**SUBJECT: PERRY NUCLEAR POWER PLANT, UNIT NO. 1 – CORRECTION TO
AMENDMENT NO. 168 TO FACILITY OPERATING LICENSE CONCERNING
CHANGES TO PRESSURE AND TEMPERATURE CURVES**

CORRECTED PAGES TO LICENSE AMENDMENT NO. 168

Technical Specification pages 3.4-31, 3.4-31a, and 3.4-31b

FIGURE 3.4.11-1(a): PRESSURE TEST CURVES (VALID UP TO 32 EFY)

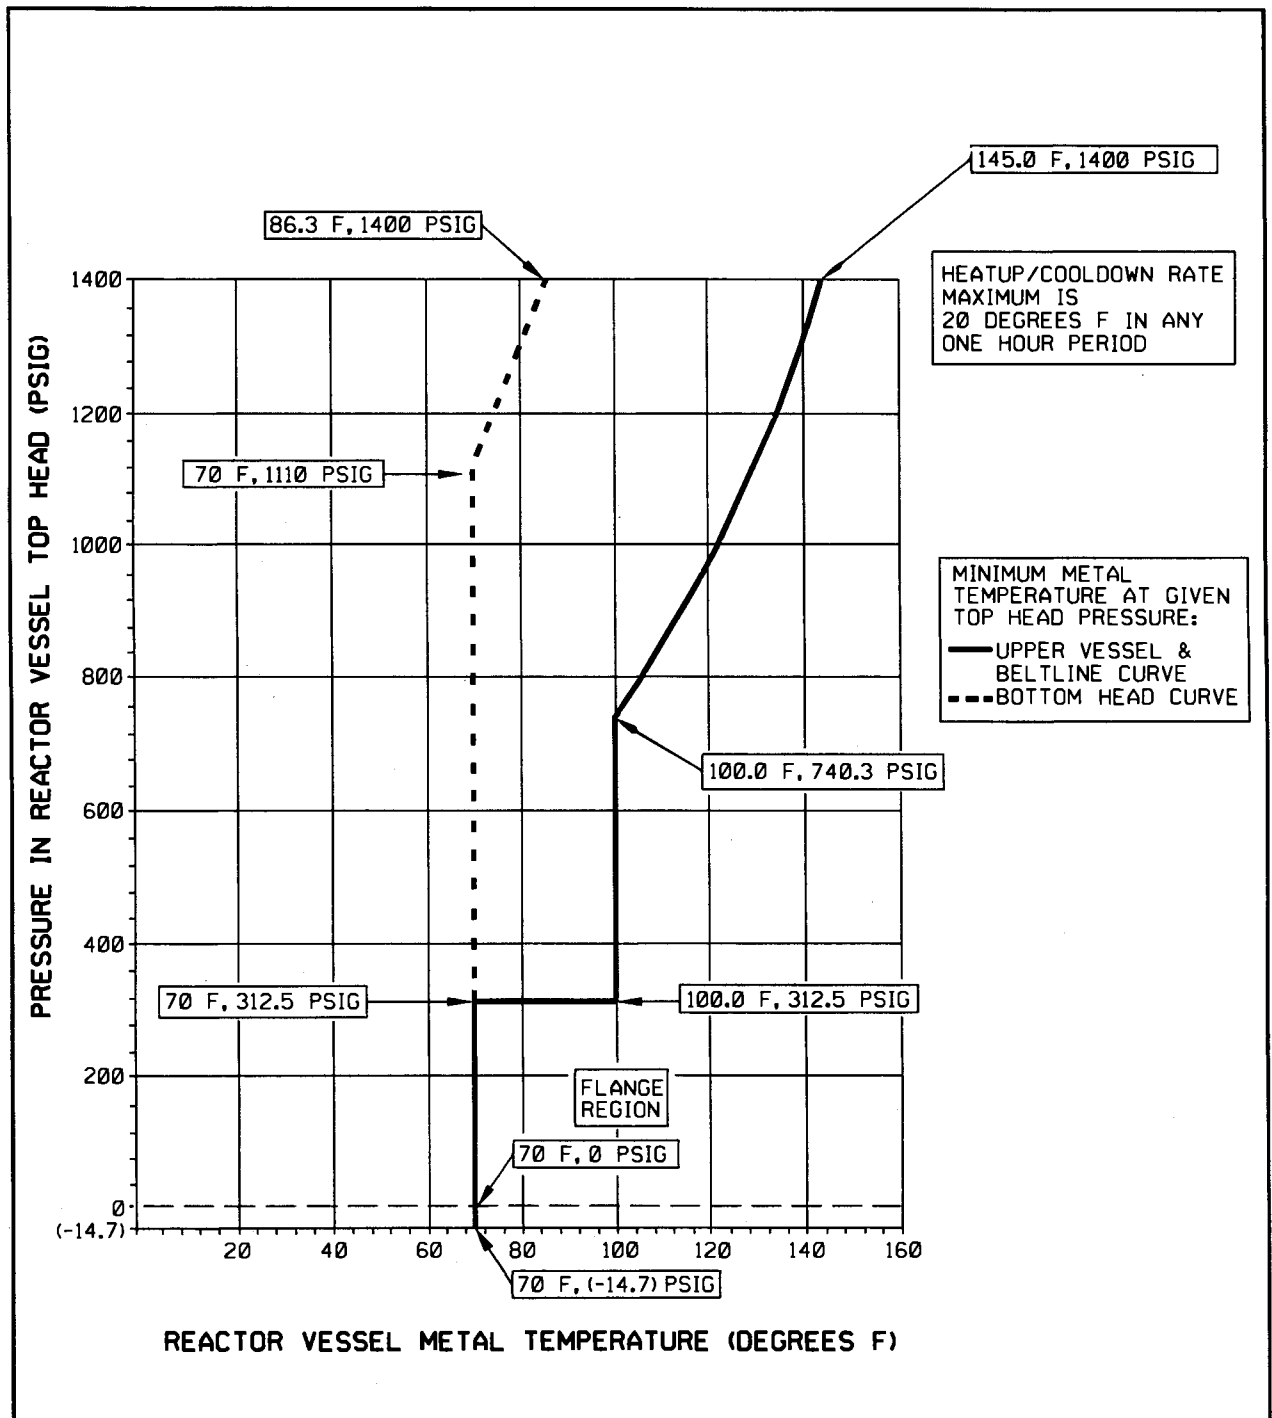
On January 15, 2019, the NRC staff identified an error on Technical Specification (TS) pages 3.4.-31, 3.4-31a, and 3.4-31b issued with Amendment No. 168. Specifically, on each pressure and temperature figure (Figures 3.4.11-1(a), 3.4.11-1(b), and 3.4.11-1(c)), the note box regarding the heatup/cooldown rate specified the rate as a temperature per hour. However, the license amendment request, dated June 23, 2014, specified the heatup/cooldown rate as a temperature limit "in any one hour period."

The NRC staff concludes that the error was inadvertently introduced during the preparation of the license amendment and is editorial in nature. The correction does not change any of the conclusions in the safety evaluation associated with the amendment and does not affect the associated notice to the public. Enclosed, please find the corrected replacement TS pages.
